# Service Kit

## 759-04143

Subject: Service Replacement for the  
42" RZT Right Hand (RH)  
Hydro Transmission

FIGURE 1

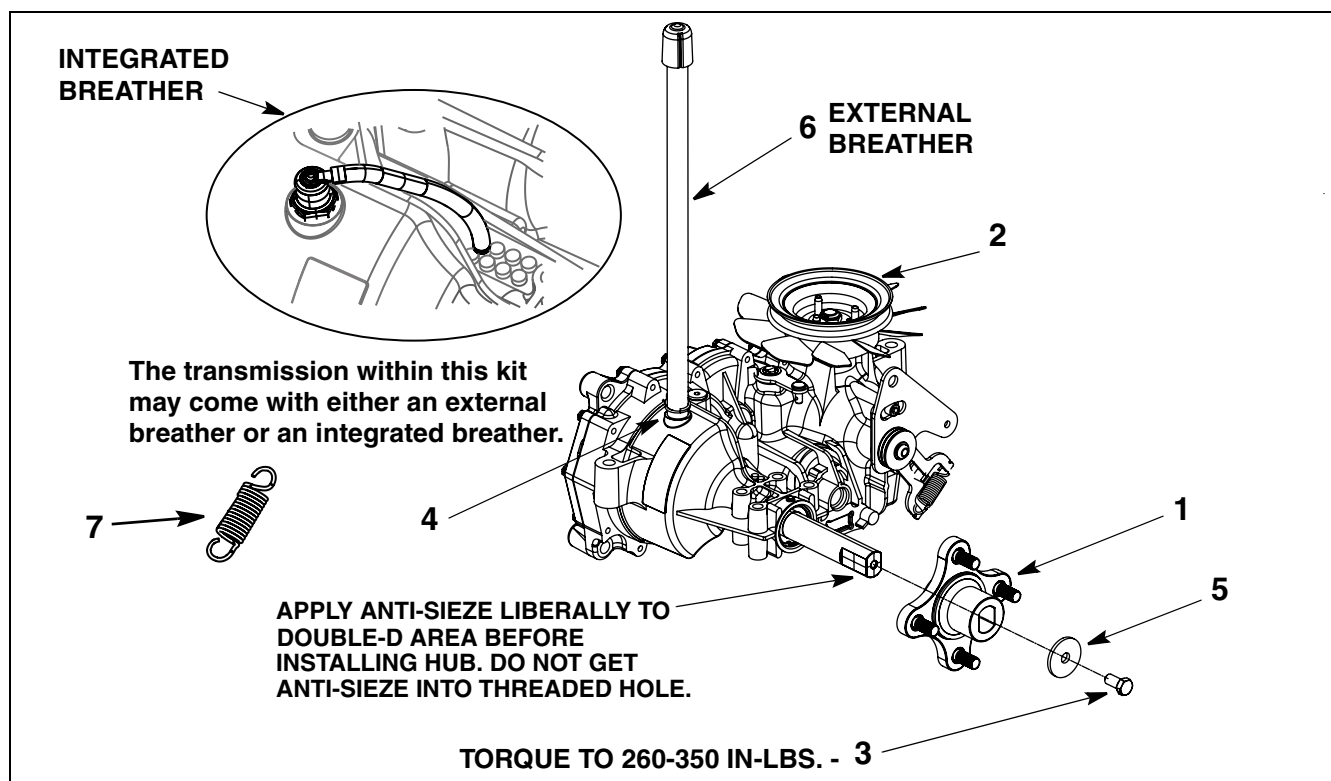
**PURPOSE:** This service kit replaces the RH hydro transmissions 618-04163A and 618-04326 which are no longer available. The replacement transmission has a Double-D axle end which requires a Double-D wheel hub assembly. A new neutral return spring is enclosed for the LH transmission. See instructions on page 2 of this sheet.

**FIGURE 2**

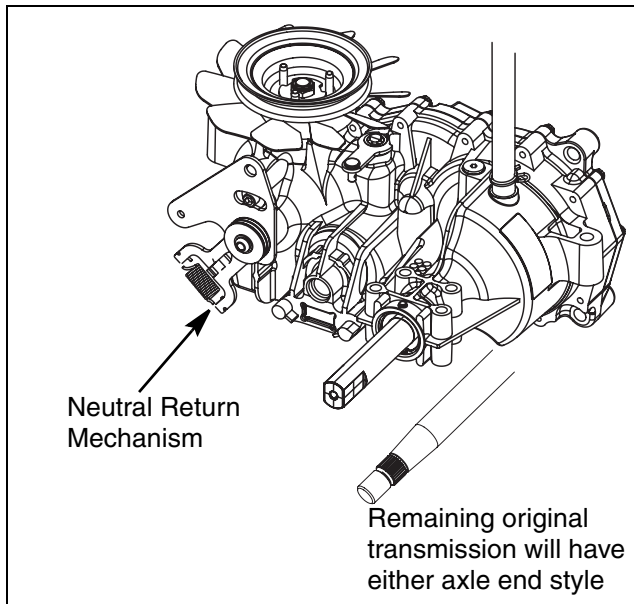
1. A Neutral Return Extension Spring, Item 7, is supplied with this kit for installation on the remaining hydrostatic transmission when only one hydrostatic transmission is being replaced.
2. This spring, Item 7, must be installed on the remaining hydrostatic transmission in order for both transmissions to come to neutral at the same rate.
3. See Figure 2 for location of the neutral return mechanism.
5. Install the new Neutral Return Spring, Item 7, onto the two arms as shown in Figure 3.
6. When complete both installed transmissions must have the same color neutral return spring.
7. This completes the installation of the new Neutral Return Spring onto the remaining original transmission.

**FIGURE 3**

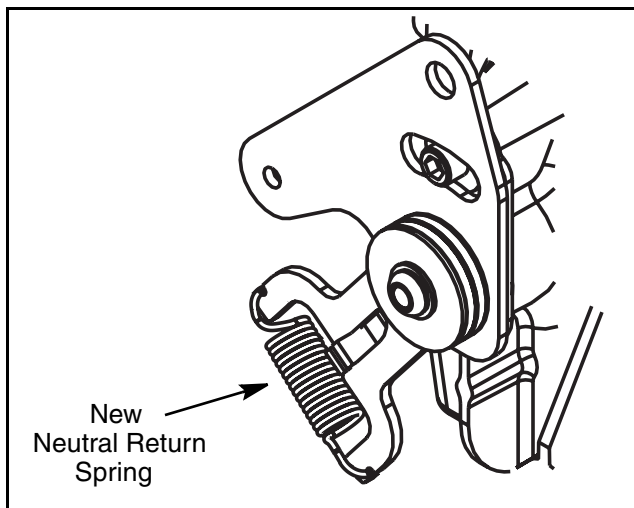
4. With a suitable set of pliers or spring removal tool, remove and discard the existing spring from the neutral return mechanisms two arms on the remaining (not replaced with this kit) hydrostatic transmission. See Figure 3.
